261, 271-281 INGLES STREET, PORT MELBOURNE

LOCATION/ADDRESS: 261, 271-281 INGLES STREET, PORT MELBOURNE
EXECUTIVE MEMBER: LILI ROSIC, GENERAL MANAGER, CITY STRATEGY AND SUSTAINABLE DEVELOPMENT
PREPARED BY: SIMON GUTTERIDGE, PLANNING TEAM LEADER FISHERMANS BEND

1.1 To provide a Council position to the Minister for Planning on an application to prepare, adopt and approve an Amendment to the Planning Scheme under Section 20(4) of the Planning and Environment Act for four multi-storey towers at 261, 271-281 Ingles Street, Port Melbourne.

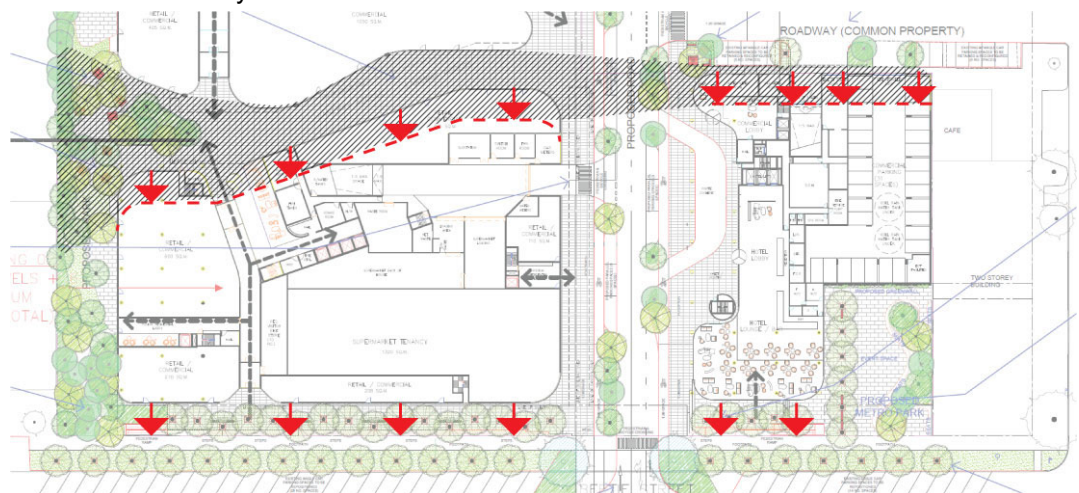
Do not support predominantly un-sleeved car parking facing the lane above ground level. Podium car parking should be sleeved by other uses.

Potential for pedestrian / vehicle conflict in design of T1. Recommend crossings be deleted from the north-south lane and the porte-cochere be shifted west away from pedestrian link.

Bertie Street interface illustrates two pedestrian ramps and steps linking the T1 and T2 developments to the street and metro park. These are not illustrated in the elevation drawings and in principle, are not supported. Recommend universally accessible gradients be incorporated in landscaped areas throughout the site to improve connectivity and access for all. Any steps or ramps linking the public realm on such a large-scale proposal can easily be avoided and justified using standard principles of universal design and landscape treatments.

Recommend Stage 1 & 2 buildings be moved west to create a street wall on the Bertie Street title boundary

Move building west to improve street wall connection with Bertie Street and open internal laneway to improved amenity

Question viability of T1 podium green wall facing the park; will it receive sunlight. Recommend wall facing the park feature active uses so car parking not visible from the public realm.

The building cannot be moved forward to the Bertie Street boundary because the land is encumbered with a restrictive covenant which requires all building to be setback 6.0m from Bertie Street. The encumbrance should be noted on the plans.
